E5071B-06D

S E R V I C E N O T E

E5071B ENA Series Network Analyzer, 300 kHz to 8.5 GHz

Change the RF signal path configuration and update firmware to 5.02 or later to improve the input damage level tolerance

**Figure 1 Front View (Semi-rigid Cables Opt. 213 before modification)**

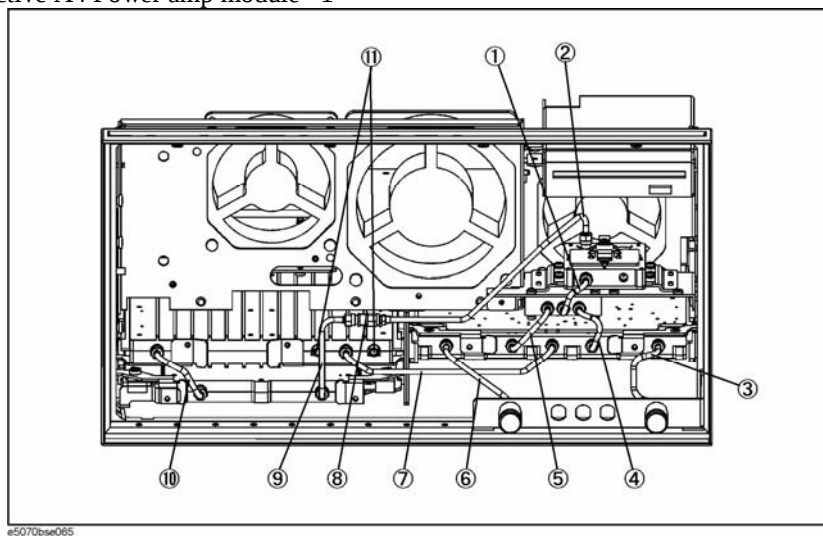
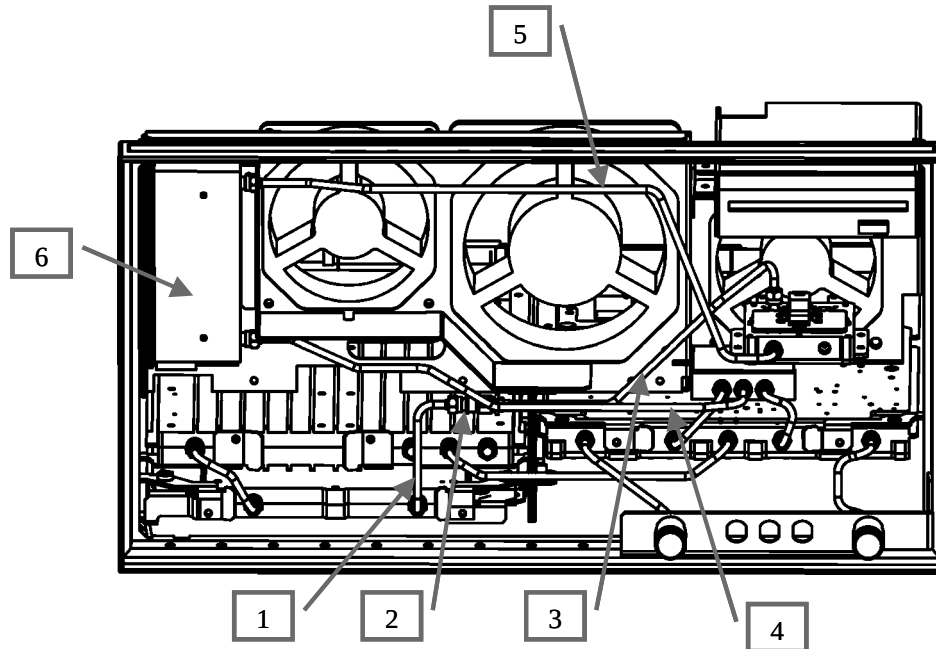
The A4 Power amp module that is located after receiver is very sensitive for electrostatic discharge (ESD) or DC transient voltage applied to test ports. If the A4 amplifier has been broken, the E5070B cannot output proper power from its test ports.

1. Remove outer cover. *1
2. Remove front panel. *1
3. Remove A28 Floppy Disk Drive (FDD) unit. *1
4. Remove semi-rigid cables in figure 1 No. 1 (E5070-61685) and No. 2 (E5070-61672)
5. Remove defective A4 Power amp module *1

8. Install new A4 power amp module to an original place.
9. Connect uW attenuator 0955-0208 (No 2 in Figure4) and A4 with E5070-61672 semi-rigid cable (No 3 in Figure 4)
10. Connect A4 and A7 ATT with E5070-61633 semi-rigid cable (No 5 in Figure 4)
11. Connect A7 ATT and A8 with E5070-61634 semi-rigid cable (No 4 in Figure 4)

Figure 6 Front View (Semirigid Cables Opt. 214 before modification)

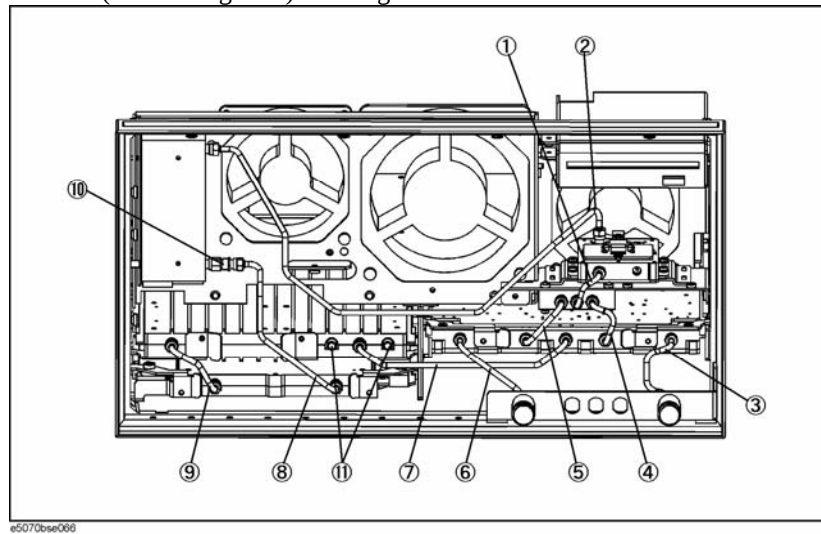
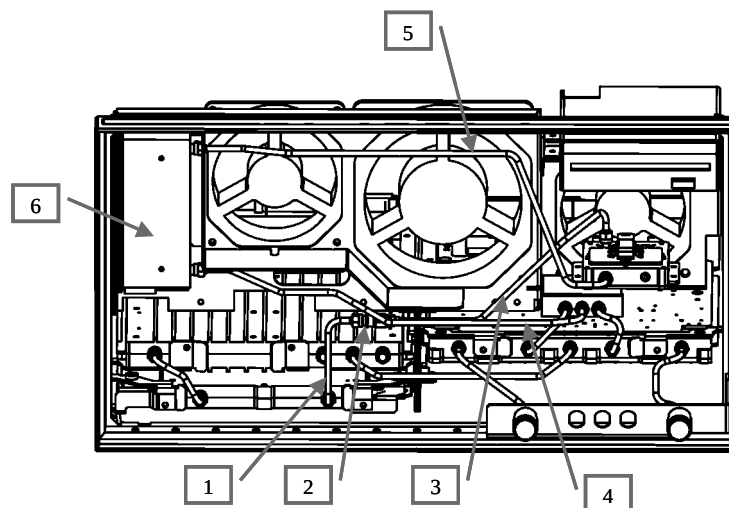
5. Remove E5070-61673 (No. 8 in Figure 6) semi-rigid cable from A3 and 0955-0208 (No 10 in Figure 6) attenuator
6. Remove 0955-0208 (No 10 in Figure 6) attenuator from A7 ATT module
7. Remove E5070-61674 (No 2 in Figure 6) semi-rigid cable from ATT and A4 amp
8. Remove E5070-61685 (No 1 in Figure 6) semi-rigid cable from A4 and A8 switch.

9. Remove defective A4 Power amp module *1
10. Remove A7 attenuator module by 2 screws.
11. Make new A7 attenuator module by 33321-60068 (1ea), E5070-61698 (1ea), E5070-61617 (1ea), 0515-0372 (2ea) and E5070-01213 (1ea). Scrap 33321-60059.
12. Install new A7 attenuator with 0515-0372 (2ea).
13. Install new A4 power amp module to an original place.
14. Connect A3 and 0955-0208 (No 2 in Figure 4, see below) attenuator with E5070-61671 (No 1 in Figure 4) semi-rigid cable
15. Connect 0955-0208 (No 2 in Figure 4) and A4 with E5070-61672 (No 3 in figure 4) semi-rigid cable
16. Connect A4 and ATT with E5070-61633 (No 5 in Figure 4) semi-rigid cable
17. Connect ATT and A8 with E5070-61634 (No 4 in Figure 4) semi-rigid cable
18. Screw E5070-01222 plate to the original place.
19. Set FDD unit.
20. Set front panel
21. Set outer cover

**Figure 7****Front View (Semi-rigid Cables Opt. 313 before modification)**

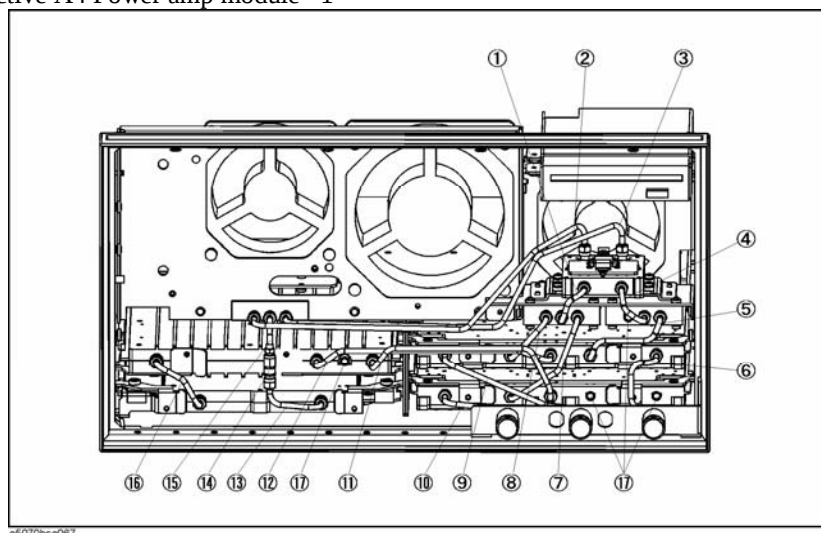
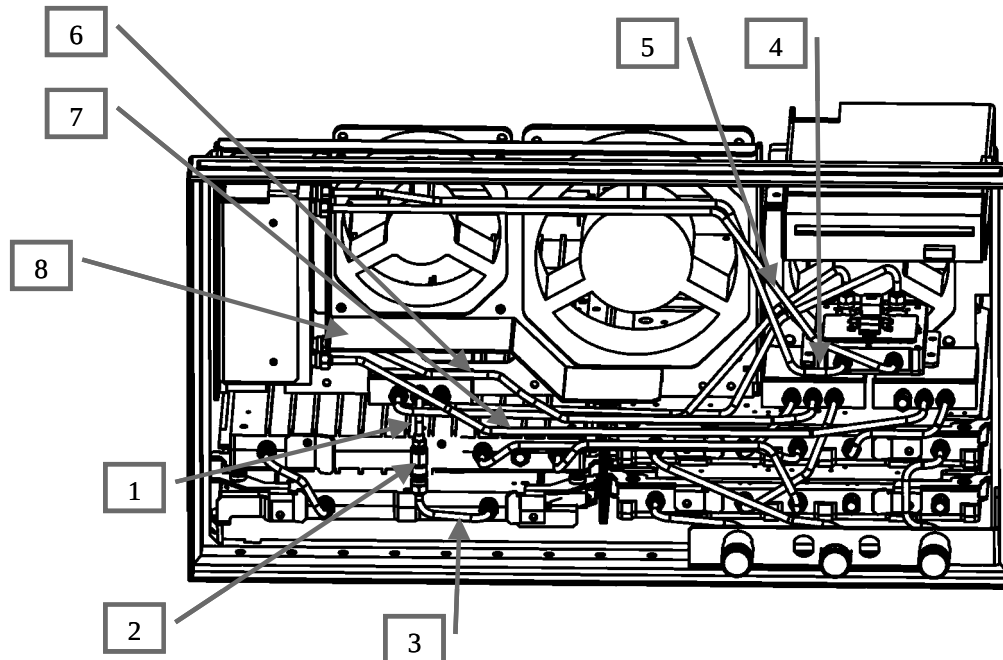
1. Remove outer cover. *1
2. Remove front panel. *1
3. Remove A28 Floppy Disk Drive (FDD) unit. *1
4. Remove E5070-01222 (No. 8 in Figure 5) plate by 3 screws (No.9 in Figure 5)
5. Remove E5070-61685 (No 1 and No 4 in Figure 7) semi-rigid cables from A4 and A8 (receiver side)
6. Remove E5070-61677 (No 2 in Figure 7) and E5070-61678 (No 3 in Figure 7) semi-rigid cables from A4 and A8 (source side)
7. Remove defective A4 Power amp module *1

10. Install new A4 power amp module to an original place.
11. Connect A8 (source side) and A4 with E5070-61677 and E5070-61678 that is removed in step 6.
12. Connect A4 and A7 ATT with E5070-61633 (No 4 in Figure10) semi-rigid cable
13. Connect A4 and A7 ATT with E5070-61635 (No 5 in Figure 10) semi-rigid cable
14. Connect ATT and A8 with E5070-61634 (No 6 in Figure 10) semi-rigid cable
15. Connect ATT and A8 with E5070-61636 (No 7 in Figure 10) semi-rigid cable

16. Screw E5070-01223 plate (No 8 in figure 10) instead of E5070-01222
17. To avoid the friction between new semi-rigid cables and front panel's cable clamp, remove two 1400-0611, cable clamp, from original place, then stick two new 1400-0611, cable clamp, as shown in Figure 11 lower. Then change a bending position of LCD flat cable (white one) according to Figure 11 upper.

Figure 12 Front View (Semirigid Cables Opt. 314 before modification)

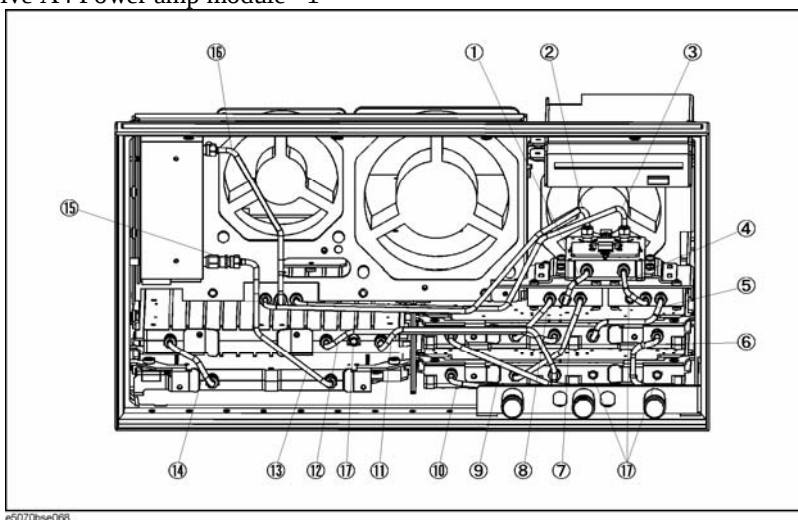
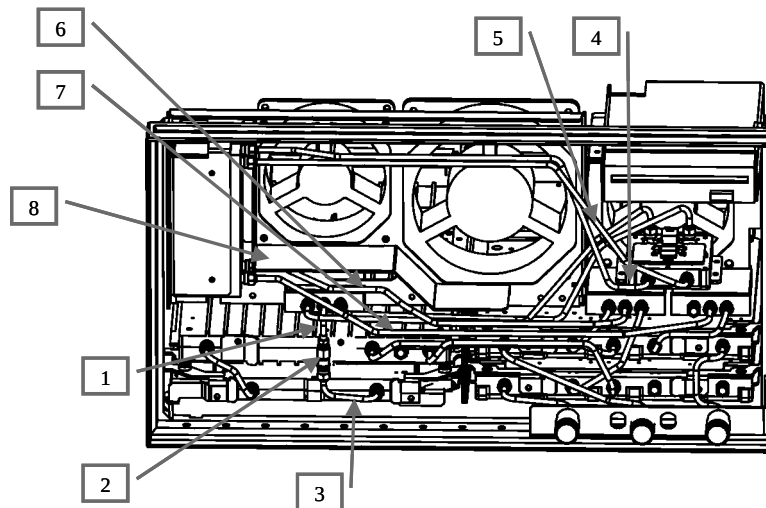
1. Remove outer cover. *1
2. Remove front panel. *1
3. Remove A28 Floppy Disk Drive (FDD) unit. *1
4. Remove E5070-01222 (No. 8 in Figure 5) plate by 3 screws (No.9 in Figure 5)
5. Remove E5070-61685 (No 1 and No 4 in Figure 12) semi-rigid cables from A4 and A8 (receiver side)
6. Remove E5070-61677 (No 2 in Figure 12) and E5070-61678 (No 3 in Figure 12) from A4 and A8 (source side)
7. Remove E5070-61673 (No 13 in Figure 12) semi-rigid cable from A3 and 0955-0301 (No 15 in Figure 12).
8. Remove 0955-0301 (No 15 in Figure 12) uW attenuator from A7 ATT
9. Remove E5070-61656 (No 16 in Figure 12) semi-rigid cable from A7 and A8
10. Remove defective A4 Power amp module *1

13. Install new A7 attenuator with 0515-0372 2 ea. Refer to Figure 9 for the detail.
14. Install new A4 power amp module to an original place
15. Connect A3 and 0955-0301 (removed in step 8) with E5070-61675 (No 3 in Figure 10, see below) semi-rigid cable

16. Connect 0955-0301 and A8 (source side) with E5070-61676 (No 1 in Figure 10)
17. Connect A8 (source side) and A4 with E5070-61677 and E5070-61678 that are removed in step 6

18. Connect A4 and A7 ATT with E5070-61633 (No 4 in Figure 10) semi-rigid cable
19. Connect A4 and A7 ATT with E5070-61635 (No 5 in Figure 10) semi-rigid cable

20. Connect ATT and A8 with E5070-61634 (No 6 in Figure 10) semi-rigid cable
21. Connect ATT and A8 with E5070-61636 (No 7 in Figure 10) semi-rigid cable

22. Screw E5070-01223 plate (No 8 in figure 10) instead of E5070-01222
23. To avoid the friction between new semi-rigid cables and front panel's cable clamp, remove two 1400-0611, cable clamp, from original place, then stick two new 1400-0611, cable clamp, as shown in Figure 11 lower. Then change a bending position of LCD flat cable (white one) according to Figure 11 upper

Figure 13 Front View (Semirigid Cables Opt. 413 before modification)

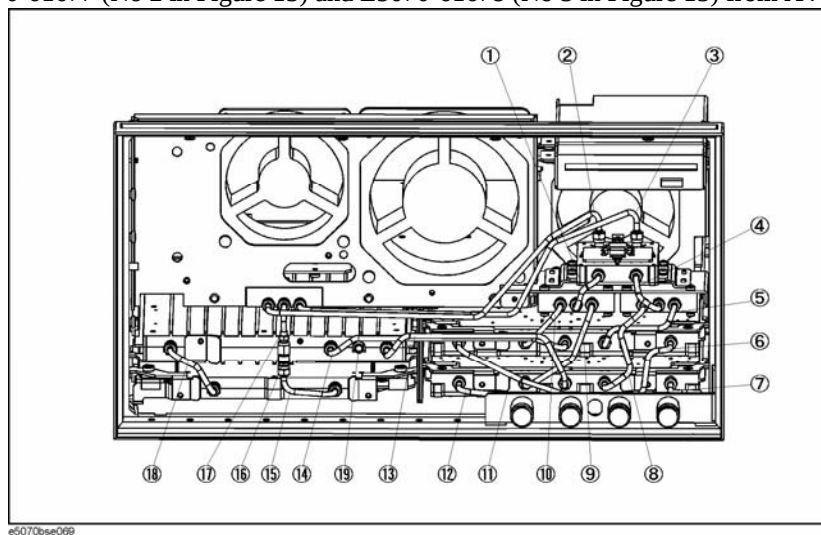
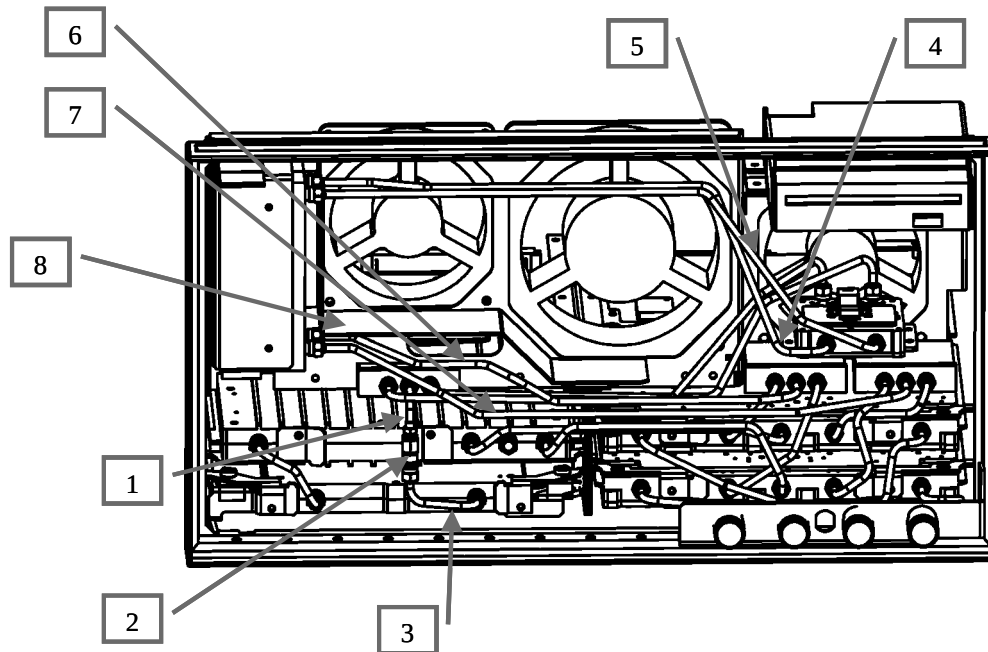
1. Remove outer cover. *1
2. Remove front panel. *1
3. Remove A28 Floppy Disk Drive (FDD) unit. *1
4. Remove E5070-01222 (No. 8 in Figure 5) plate by 3 screws (No.9 in Figure 5)
5. Remove E5070-61685 (No 1 and No 4 in Figure 13) semi-rigid cables from A4 and A8 (receiver side)
6. Remove E5070-61677 (No 2 in Figure 13) and E5070-61678 (No 3 in Figure 13) from A4 and A8 (source side)

8. Make A7 step attenuator assembly by 33321-60068 (2ea), E5070-61698 (2ea), E5070-01214 (1ea), 0515-0372 (4ea), and E5070-61618 (1ea). Refer to Figure 8 for the detail.
9. Install A7 assembly with 0515-0372 2 ea. Be careful to the flat cable's direction and connection. Refer to Figure 9 for the detail.
10. Install new A4 power amp module to an original place
11. Connect A8 (source side) and A4 with E5070-61677 and E5070-61678 that are removed in step 6
12. Connect A4 and A7 ATT with E5070-61633 (No 4 in Figure 14) semi-rigid cable
13. Connect A4 and A7 ATT with E5070-61635 (No 5 in Figure 14) semi-rigid cable
14. Connect ATT and A8 with E5070-61634 (No 6 in Figure 14) semi-rigid cable
15. Connect ATT and A8 with E5070-61636 (No 7 in Figure 14) semi-rigid cable
16. Screw E5070-01223 plate (No 8 in figure 14) instead of E5070-01222

Figure 15 Front View (Semirigid Cables Opt. 414 before modification)

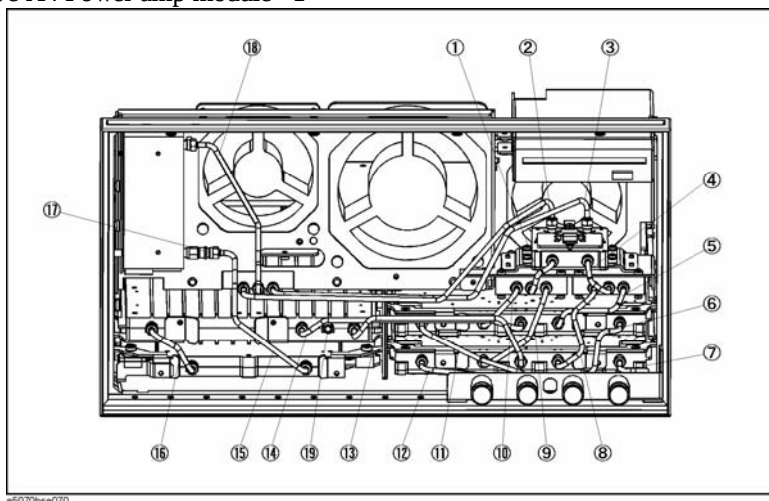
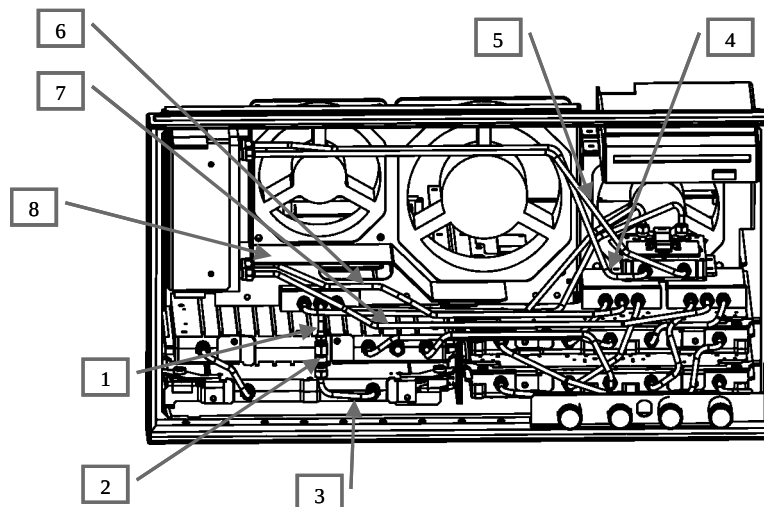
1. Remove outer cover. *1
2. Remove front panel. *1
3. Remove floppy disk drive unit. *1
4. Remove E5070-01222 (No. 8 in Figure 5) plate by 3 screws (No.9 in Figure 5)
5. Remove E5070-61685 (No 1 and No 4 in Figure 15) semi-rigid cables from A4 and A8
6. Remove E5070-61677 (No 2 in Figure 15) and E5070-61678 (No 3 in Figure 15) from A4 and A8 (source side)
7. Remove E5070-61673 (No 15 in Figure 15) semi-rigid cable from A3 and 0955-0301 (No 17 in Figure 15).
8. Remove 0955-0301 (No 17 in Figure 15) uW attenuator from A7 ATT
9. Remove E5070-61656 (No 18 in Figure 15) semi-rigid cable from A7 and A8
10. Remove defective A4 Power amp module *1

13. Install new A7 attenuator with 0515-0372 2 ea. Refer to Figure 9 for the detail.
14. Install new A4 power amp module to an original place
15. Connect A3 and 0955-0301 (removed in step 8) with E5070-61675 (No 3 in Figure 14, see below) semi-rigid cable

16. Connect 0955-0301 and A8 (source side) with E5070-61676 (No 1 in Figure 14)
17. Connect A8 (source side) and A4 with E5070-61677 and E5070-61678 that are removed in step 6

18. Connect A4 and A7 ATT with E5070-61633 (No 4 in Figure 14) semi-rigid cable
19. Connect A4 and A7 ATT with E5070-61635 (No 5 in Figure 14) semi-rigid cable

20. Connect ATT and A8 with E5070-61634 (No 6 in Figure 14) semi-rigid cable
21. Connect ATT and A8 with E5070-61636 (No 7 in Figure 14) semi-rigid cable

22. Screw E5070-01223 plate (No 8 in figure 14) instead of E5070-01222
23. To avoid the friction between new semi-rigid cables and front panel's cable clamp, remove two 1400-0611, cable clamp, from original place, then stick two new 1400-0611, cable clamp, as shown in Figure 11 lower. Then change a bending position of LCD flat cable (white one) according to Figure 11 upper
